Interactive comment on “Assessing the potential hydrological impact of the Gibe III Dam on Lake Turkana water level using multi-source satellite data” by N. M. Velpuri and G. B. Senay

Author's Response to Short Comment by M. Gebremicheal

Figure 2. Revised manuscript will be updated with Figure 2 on the left. Right: Existing figure 2 in manuscript

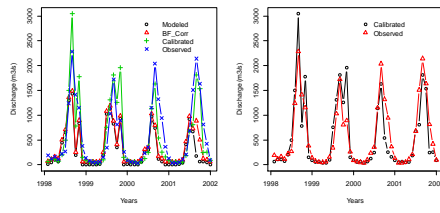
Comment #8: On Section 4.1: L 4 what do you mean by "initial comparison"? The whole paragraph is not clear. Which statements do refer to Fig 2 and which statements refer to elsewhere?

Author's response: We agree with the comment that section 4.1 is not clear. Actually, in published Figure 2, we showed only model calibrated vs. observed runoff data and removed un-calibrated runoff data to avoid the clutter. We would add un-calibrated and base flow corrected data to Figure 2 that would demonstrate the underestimation in the modeled runoff data and would also improve the explanation of figure 2 in Section 4.1. Further, we will re-phrase the text in section 4.1 to convey the message clearly. See below for a comparison of new figure and existing Figure 2 in the HESSD manuscript. The new figure shows model un-calibrated (black circles), base flow corrected (red triangles), model calibrated (green plus) and observed runoff data (blue cross).
